Request for Modification to License (Corrected Configuration)

December 13, 2019

UAV Network: Configuration 2 (Revised)

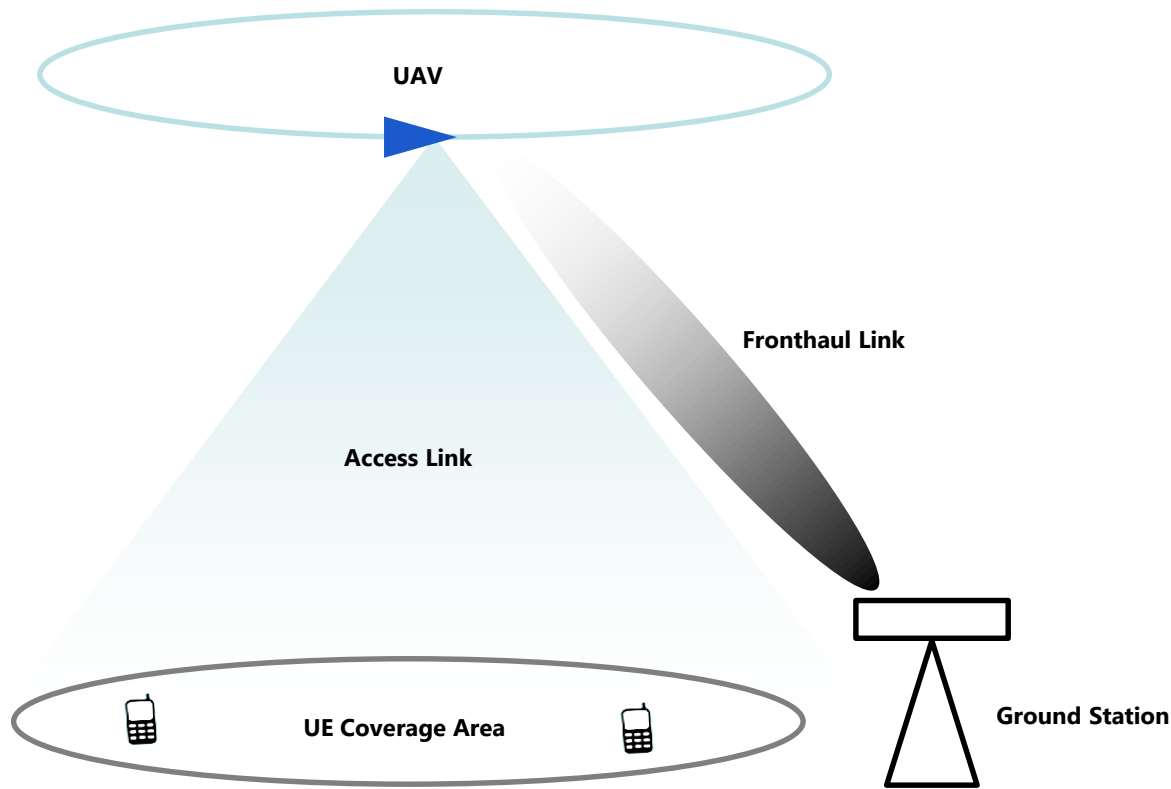
- The modification request is solely to increase the maximum peak transmission power from 20W to 31.6 kW for the 2110-2200 MHz at the Jornada NM test site and 2100-2200 at the Apache City, CO test site, frequencies.
- These frequencies pertain to the establishment and performance evaluation of a UAV communications network with Configuration 2 (seen next slide). This slide has been revised to correctly represent the uplink and downlink frequencies from the ground station to UAV
- The purpose of the modification is to enable the use of up to a 4 x16 MMIMO directional antenna array, for a ground station to UAV link, with optional power amplification, for 5G applications.
- All other characteristics of the original application remain unchanged.

Transmission
Frequencies (MHz)

UAV to UE

- 2620-2690

GS to UAV

- 2110-2200 (NM)
- 2100-2200 (CO)

UAV to GS

- 1920-2010
